Service Bulletin

Bulletin No. 2016-02 OEM No. 2016-02

Steering Information for Multiple Engine Applications

8M0114897

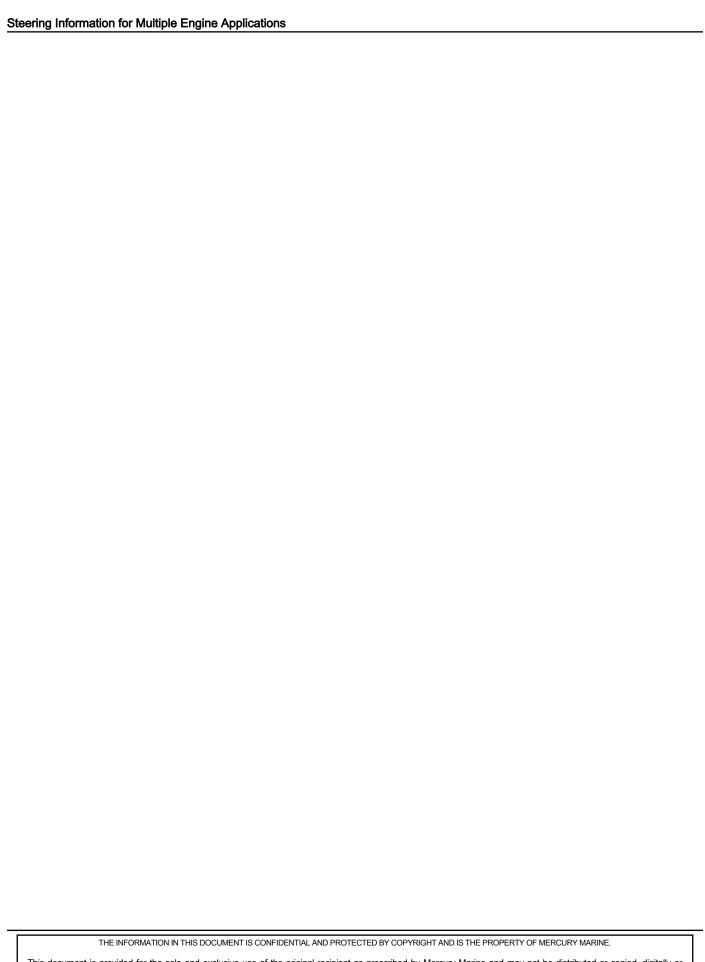
Applications with multiple Verado 350 engines must have a minimum of two steering cylinders. When installing two cylinders in this type of application, it will be necessary to use a 50 cc or greater displacement helm to limit the number of turns lock to lock.

A decal will be installed on the steering cover of all counterrotation engines that are shipped from the factory.

Avoid momentary loss of steering control caused by high steering forces. Multiple engine installations must have a minimum of two steering cylinders.
